**NEW YORK STATE THRUWAY AUTHORITY  
DEPARTMENT OF ENGINEERING**

**AMENDMENT NO. 2  
TO**

**CONTRACT TANY 26-17B  
D215020  
REPLACEMENT OF THE PINE HILL ROAD  
BRIDGE OVER I-87 AT MP 47.58,  
REHABILITATION OF I-87 BRIDGE OVER  
SMITH CLOVE ROAD AT MP 47.04,  
AND RESURFACING AND SAFETY IMPROVEMENTS  
ON I-87 BETWEEN MP 46 AND MP 48  
IN THE NEW YORK DIVISION  
OF THE NEW YORK STATE THRUWAY  
IN ORANGE COUNTY**

**IN THE LETTING OF  
JUNE 17, 2026**

PROPOSED RECONSTRUCTION OF DECK OVERHANG REINFORCEMENT-PLAN

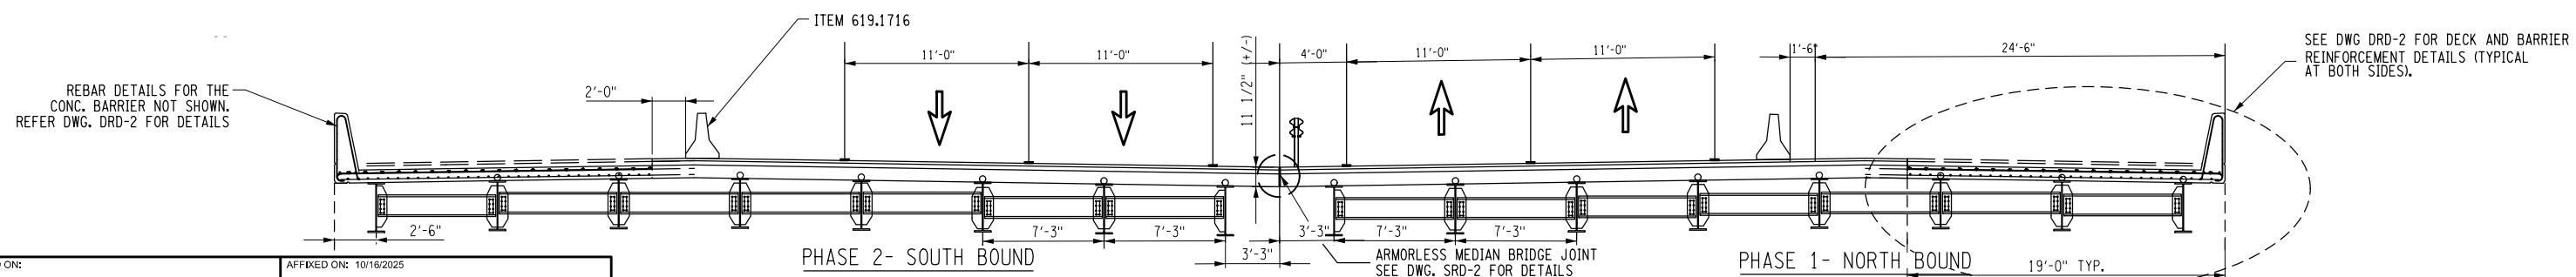
31. **DELETE** Drawing Number DRD-1, Sheet 160 of 180, and **SUBSTITUTE** with the attached Drawing Number DRD-1, Sheet 160A2 of 180. In the Proposed Reconstruction of Deck Overhang Reinforcement Plan, the Bridge Begin and Bridge End Station references have been added at the centerline of the Thruway. The bar marks have also been revised. The reference to the reinforcement details for the deck and concrete barrier as called out on both ends of the Section A-A detail have

TITLE OF PROJECT I-87 BRIDGE REHABILITATION OVER SMITH CLOVE ROAD (MP 47.04)	CONTRACT NUMBER: TANY 26-17B
LOCATION OF PROJECT VILLAGE OF WOODBURY ORANGE COUNTY BIN 5514279	DATE: 05/21/2025
TITLE OF DRAWING CONCRETE REPAIR AREAS	DRAWING NUMBER: CRA-1

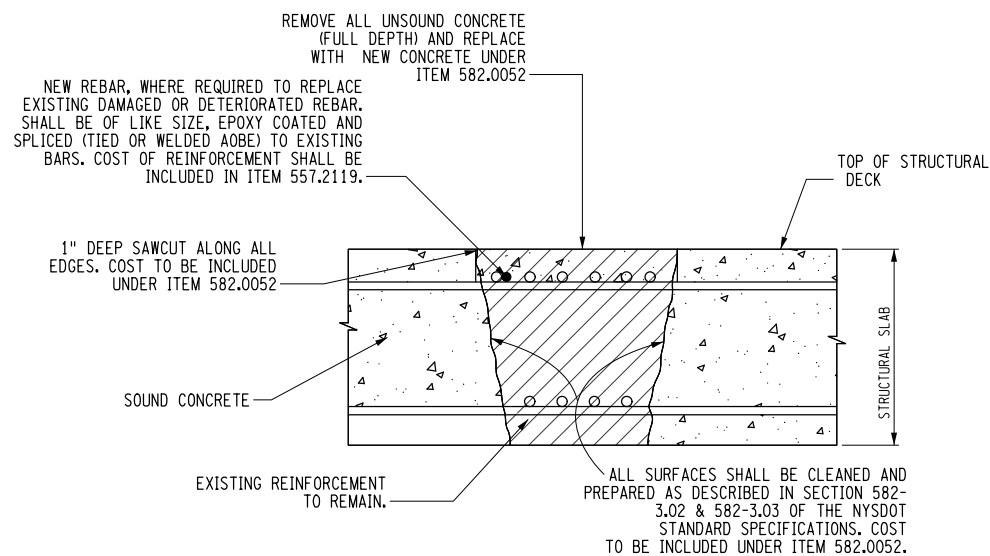
33. **DELETE** Drawing Number CRA-1, Sheet 162 of 180, and **SUBSTITUTE** with the attached Drawing Number CRA-1, Sheet 162A2 of 180. The item number for deck repairs has been corrected to Item 582.0052 in the Table. The Drawing Number reference in Note 2 has been corrected.

TITLE OF PROJECT 1-87 BRIDGE REHABILITATION OVER SMITH CLOVE ROAD (MP 47.04)	CONTRACT NUMBER: TANY 26-17B
	LOCATION OF PROJECT VILLAGE OF WOODBURY ORANGE COUNTY BIN 5514279	DATE: 05/21/2025
	TITLE OF DRAWING BEGIN ABUTMENT ELEVATION (SHEET 1 OF 2)	DRAWING NUMBER: BA-1

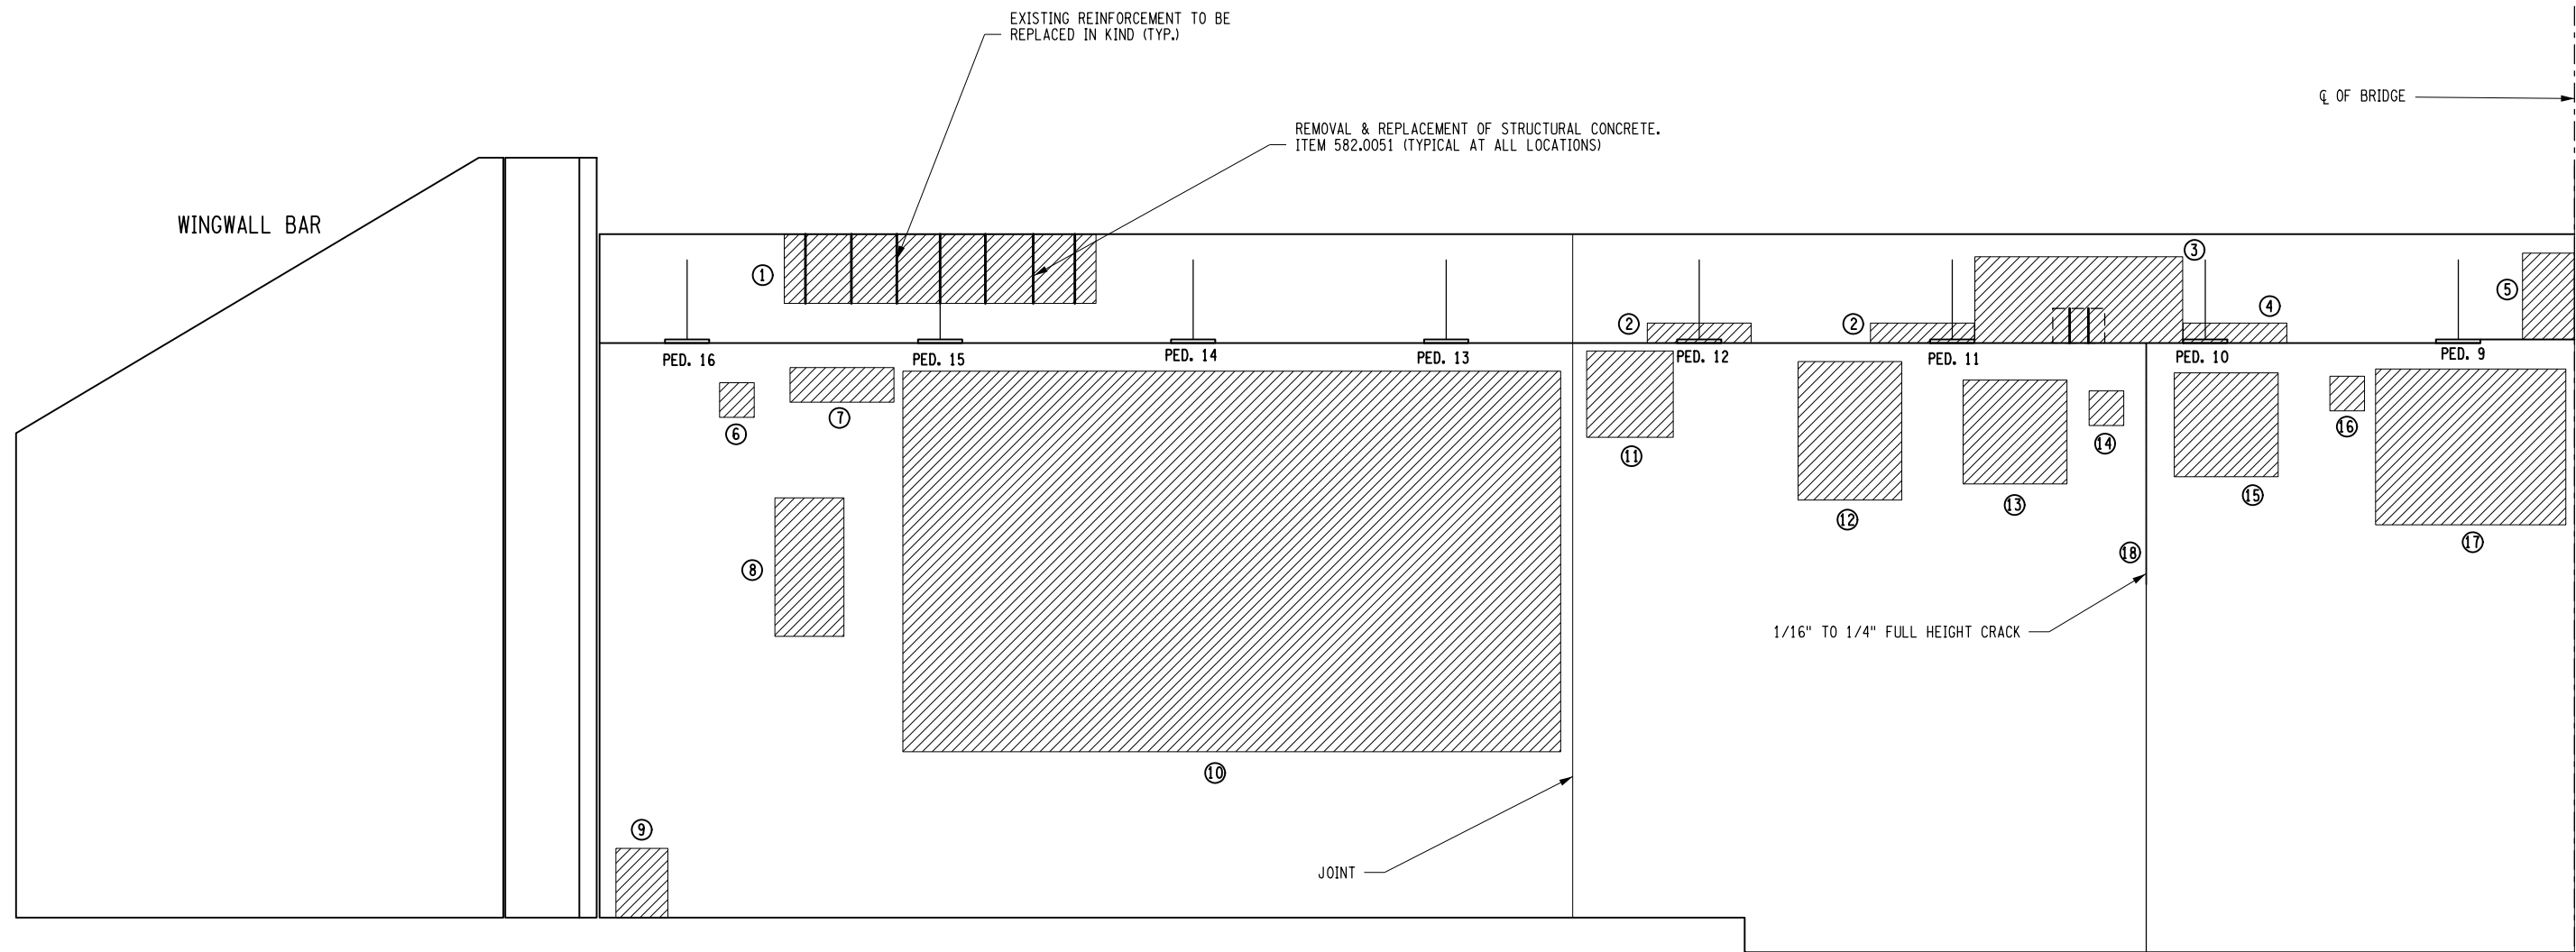
35. **DELETE** Drawing Number BA-1, Sheet 164 of 180, and **SUBSTITUTE** with the attached Drawing Number BA-1, Sheet 164A2 of 180. The right begin abutment wingwall has been labeled accordingly.

TITLE OF PROJECT 1-87 BRIDGE REHABILITATION OVER SMITH CLOVE ROAD (MP 47.04)	CONTRACT NUMBER: TANY 26-17B
	LOCATION OF PROJECT VILLAGE OF WOODBURY ORANGE COUNTY BIN 5514279	DATE: 05/21/2025
	TITLE OF DRAWING BEGIN ABUTMENT ELEVATION (SHEET 2 OF 2)	DRAWING NUMBER: BA-2

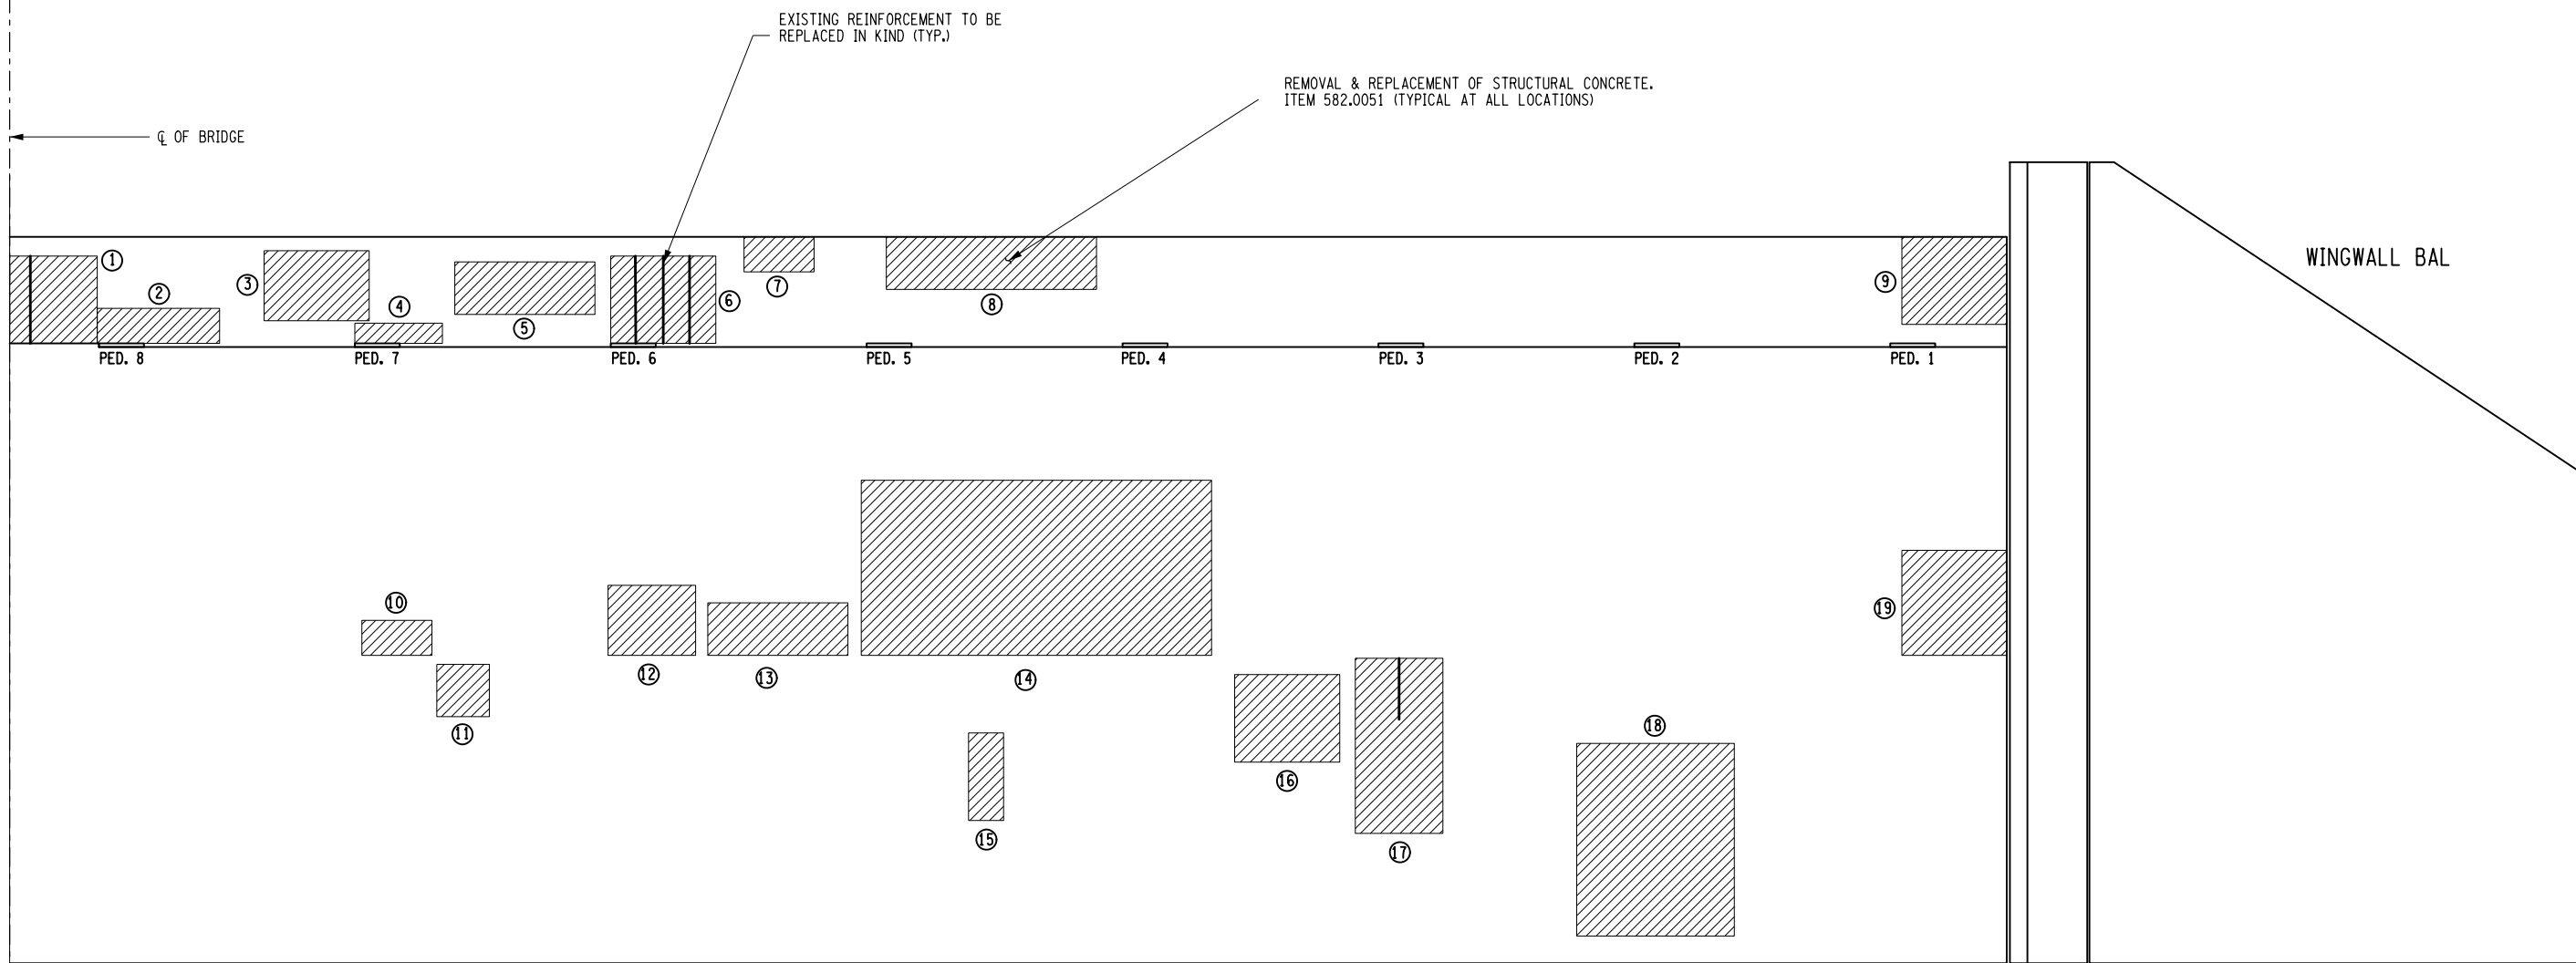
36. **DELETE** Drawing Number BA-2, Sheet 165 of 180, and **SUBSTITUTE** with the attached Drawing Number BA-2, Sheet 165A2 of 180. The left begin abutment wingwall has been labeled accordingly.

TITLE OF PROJECT 1-87 BRIDGE REHABILITATION OVER SMITH CLOVE ROAD (MP 47.04)	CONTRACT NUMBER: TANY 26-17B
	LOCATION OF PROJECT VILLAGE OF WOODBURY ORANGE COUNTY BIN 5514279	DATE: 05/21/2025
	TITLE OF DRAWING END ABUTMENT ELEVATION (SHEET 1 OF 2)	DRAWING NUMBER: EA-1

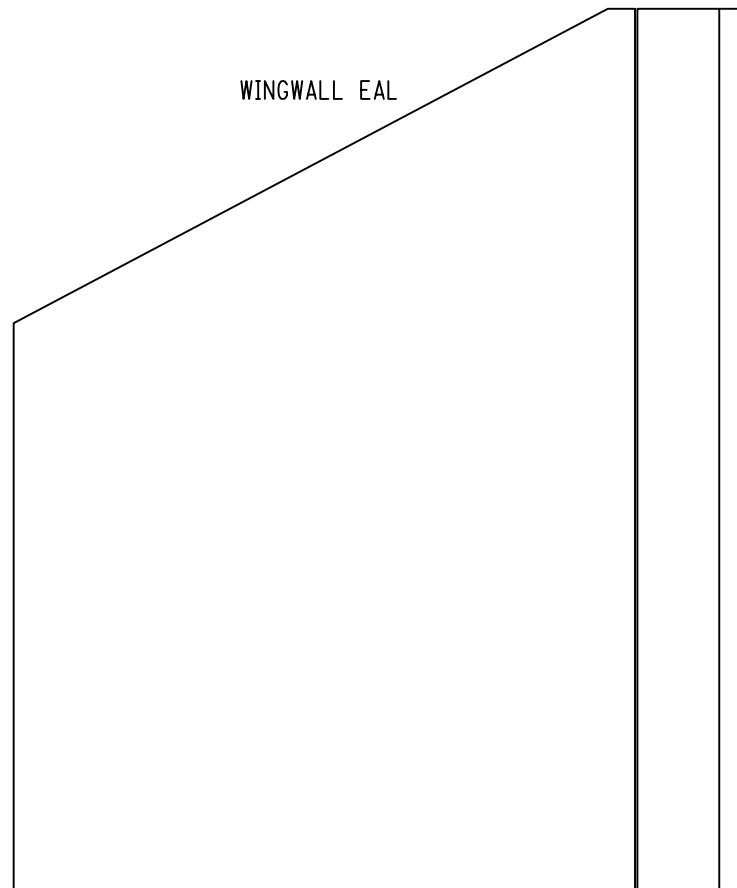
37. **DELETE** Drawing Number EA-1, Sheet 166 of 180, and **SUBSTITUTE** with the attached Drawing Number EA-1, Sheet 166A2 of 180. The left end abutment wingwall has been labeled accordingly.

TITLE OF PROJECT 1-87 BRIDGE REHABILITATION OVER SMITH CLOVE ROAD (MP 47.04)	CONTRACT NUMBER: TANY 26-17B
	LOCATION OF PROJECT VILLAGE OF WOODBURY ORANGE COUNTY BIN 5514279	DATE: 05/21/2025
	TITLE OF DRAWING END ABUTMENT ELEVATION (SHEET 2 OF 2)	DRAWING NUMBER: EA-2

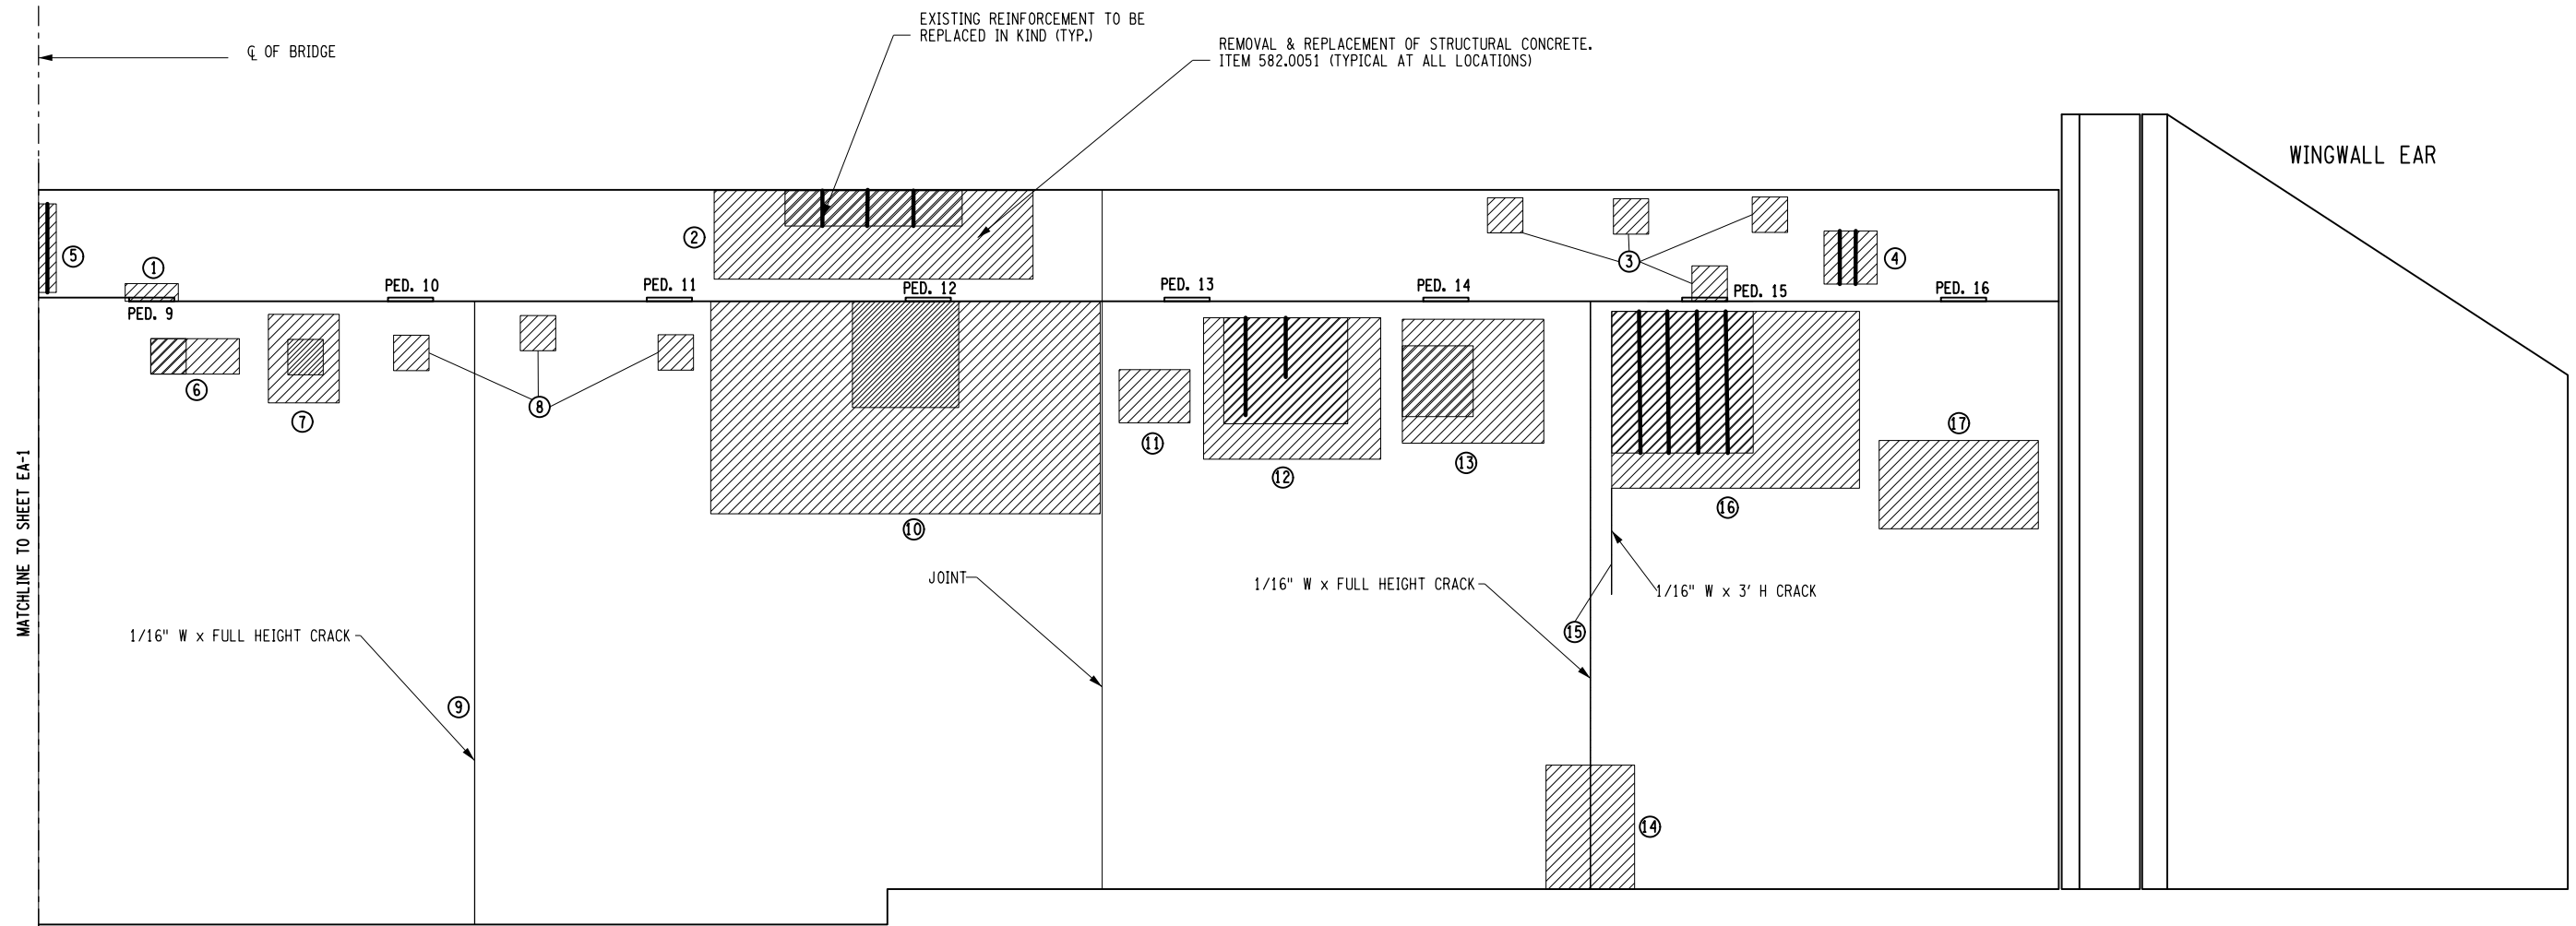
38. **DELETE** Drawing Number EA-2, Sheet 167 of 180, and **SUBSTITUTE** with the attached Drawing Number EA-2, Sheet 167A2 of 180. The right end abutment wingwall has been labeled accordingly.
